Proposed co-channel separation distances

Paragraph 41 of the NPRM/NOI, PR Docket No. 92-257, proposes a separation matrix between I/LT stations and navigable waterways and co-channel public coast stations. These geographic separations are based on protecting maritime operations within 43 kilometers (27 miles) of any co-channel public coast station. Footnote 73 states that:

George L. Schrenk, Ph.D.
Chairman/CEO
Comp Comm, Inc.

**EXHIBIT 1. Required Minimum Seraration Distance
Base-to-Mobile Communications - Paired Channels**

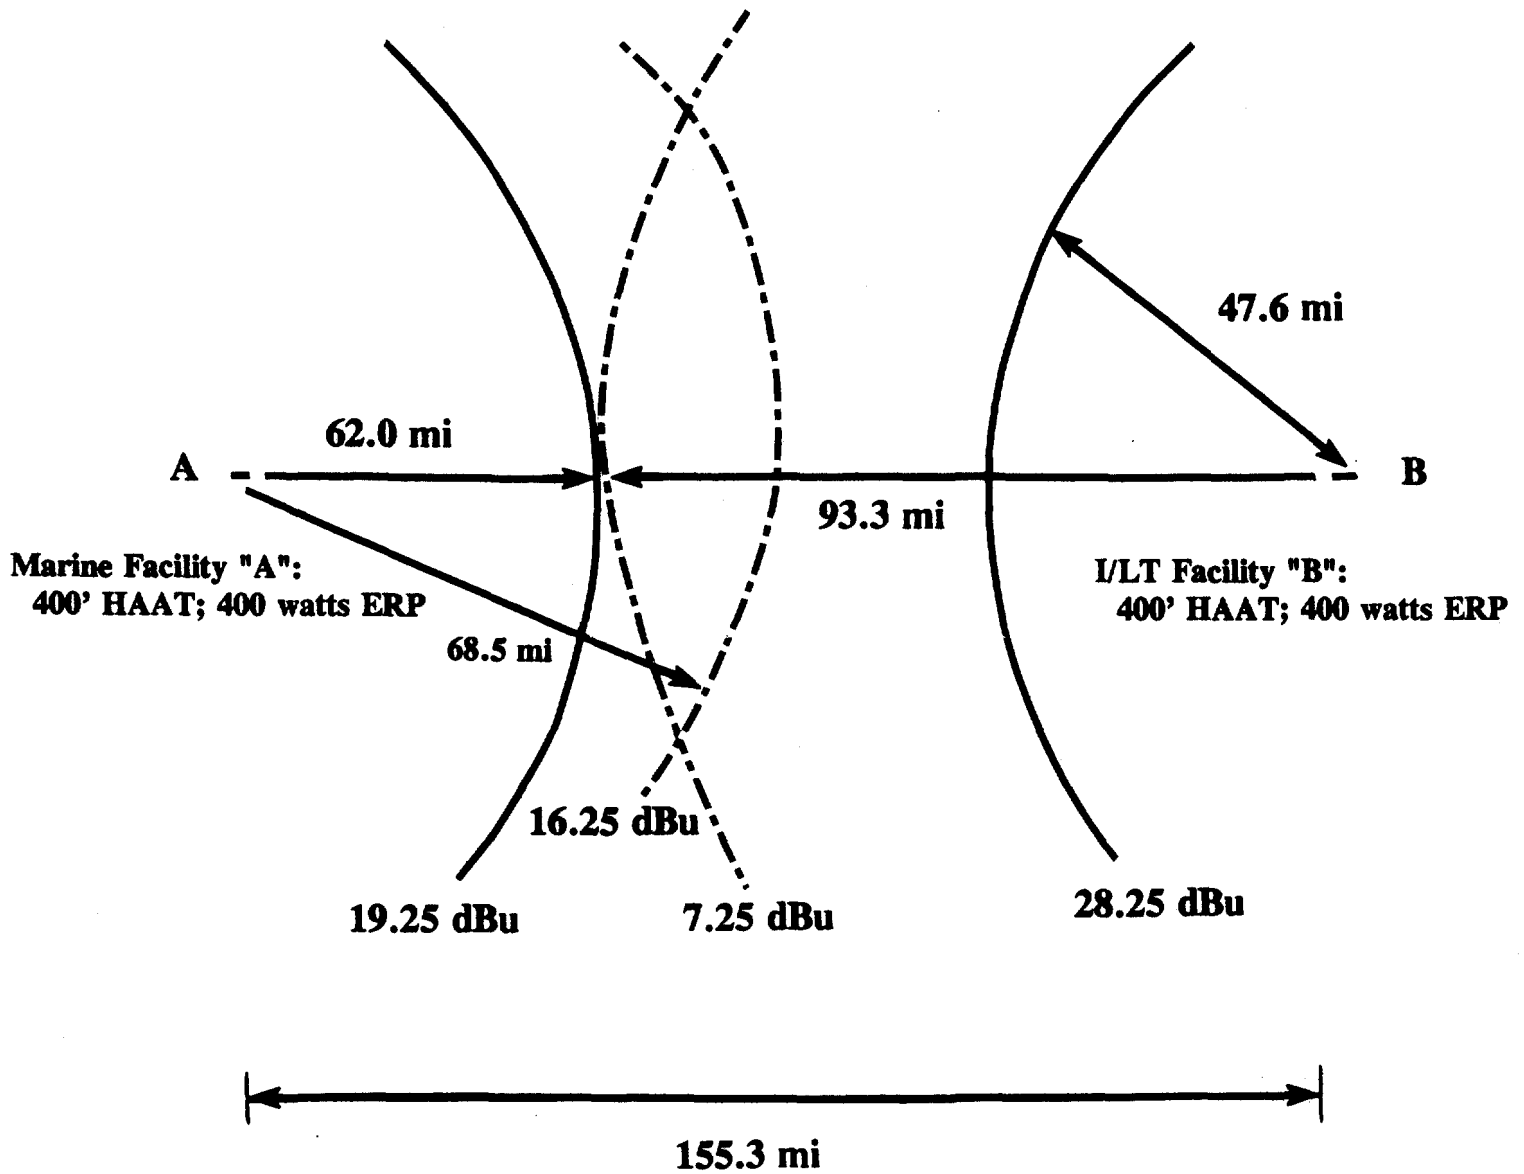
The separation distance for neither facility to experience interference is the larger of the sum of the service contour and opposite interference contour³, namely:

Marine Service + I/LT Interf: $62.0 + 93.3 = 155.3$ mi.
I/LT Service + Marine Interf: $47.6 + 68.5 = 116.1$ mi.

The larger value is the required separation distance--namely 155.3 mi. This is illustrated in Exhibit 1.

**EXHIBIT 2. Required Minimum Separation Distance
Base-to-Mobile Communications - Paired Channels**

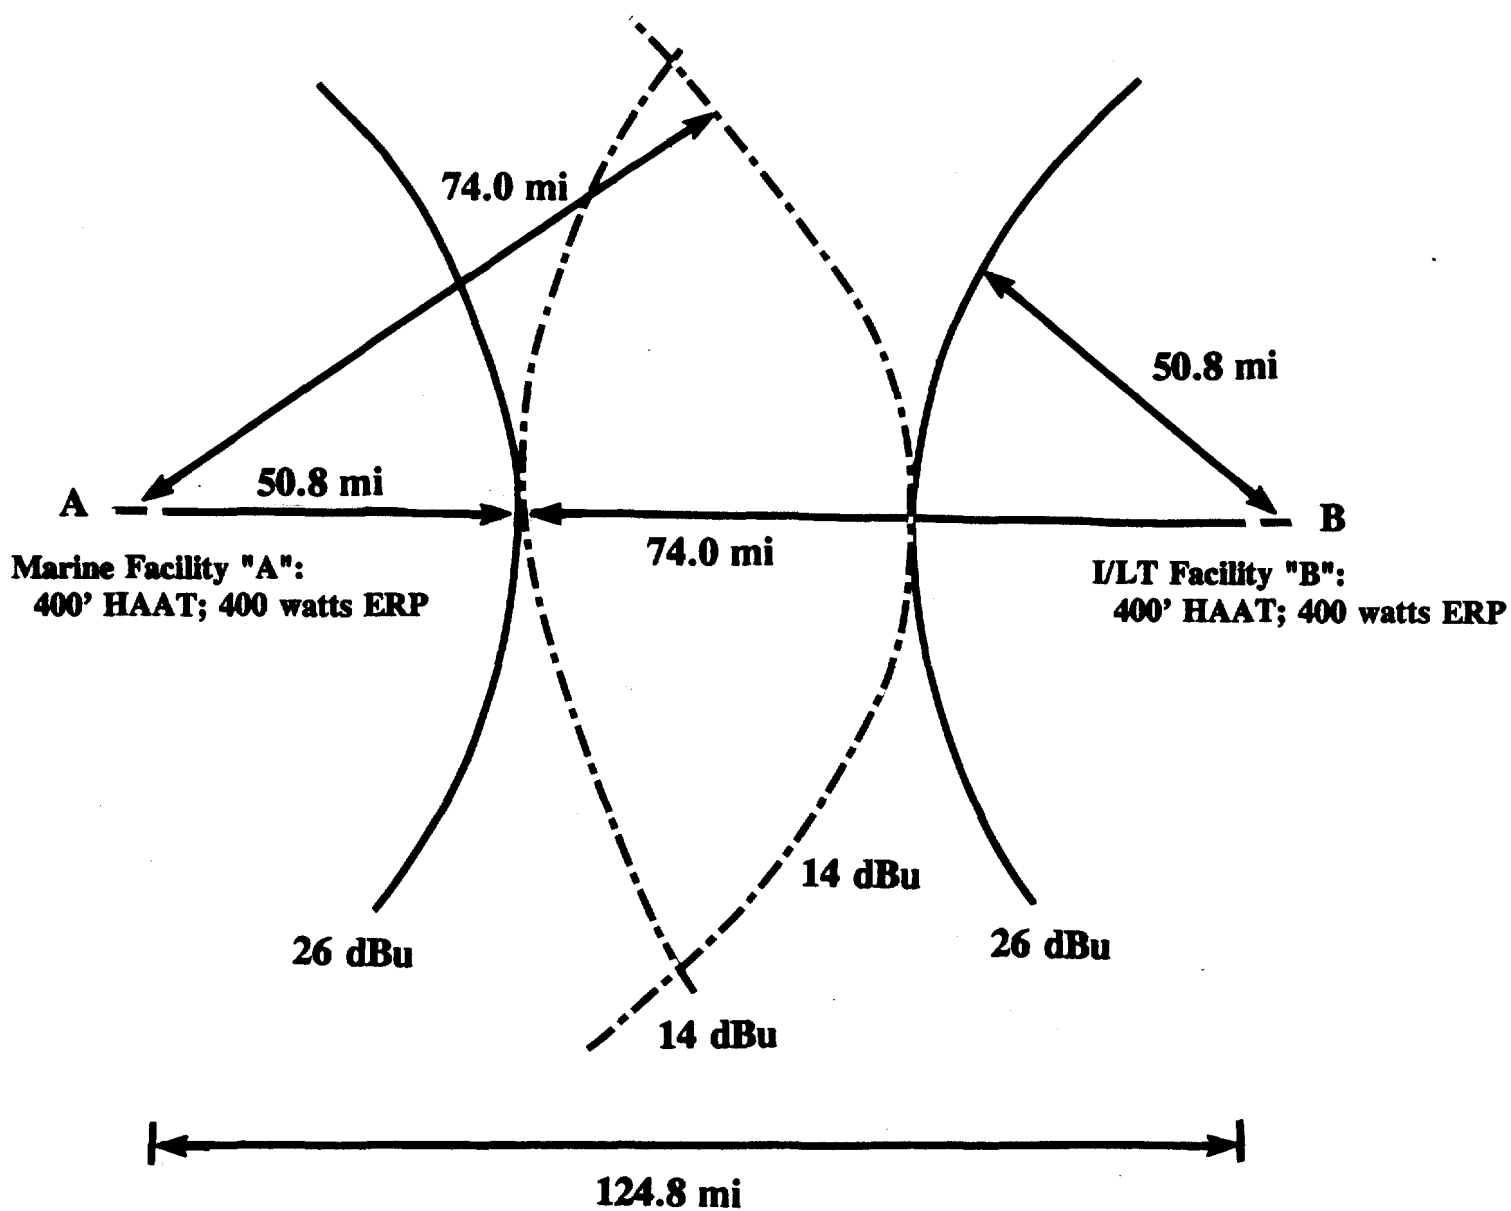
The NPRM/NOI appears to suggest a 17 dBu signal level for a 6 ft receiver be protected for both the I/LT mobiles and the over-land marine mobiles.⁴ Applying a 9 dB correction for 30' receive height, this means that both the marine over-land and I/LT facilities have a 26 dBu service contour and a 14 dBu interference contour. No over-land terrain roughness correction was applied.

The separation distance for neither facility to experience interference is the larger of the sum of the service contour and opposite interference contour, namely:

Marine Service + I/LT Interf: $50.8 + 74.0 = 124.8$ mi.
I/LT Service + Marine Interf: $50.8 + 74.0 = 124.8$ mi.

The larger value is the required separation distance--namely 124.8 mi. This is illustrated in Exhibit 2.
